PRT-0025 Main PCBA

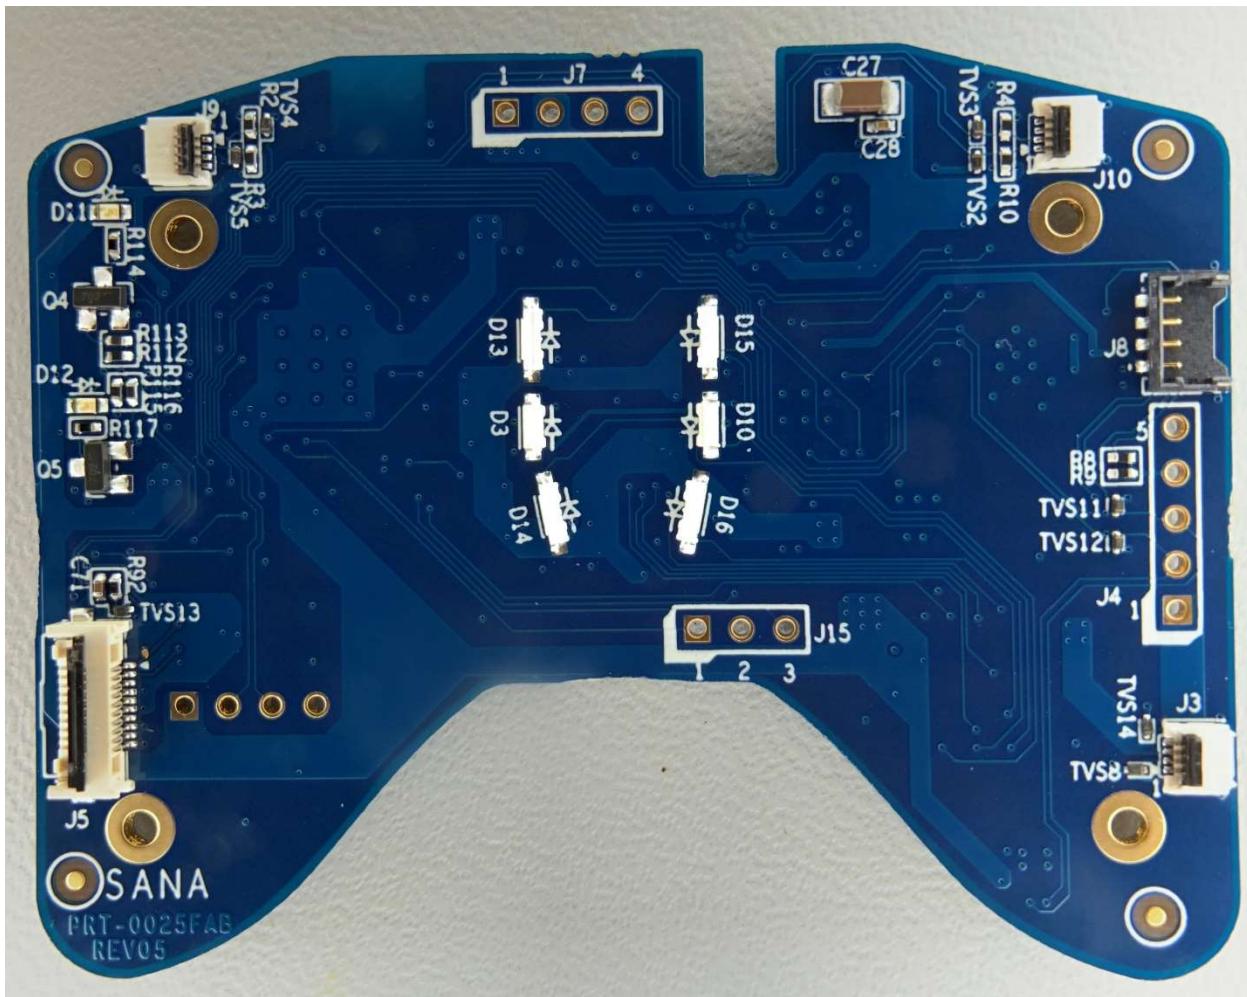
- 1) Change to blue solder mask
- 2) Update of rev number to REV05

- 1) Change to blue solder mask
- 2) Removal of ground connections to ANT1
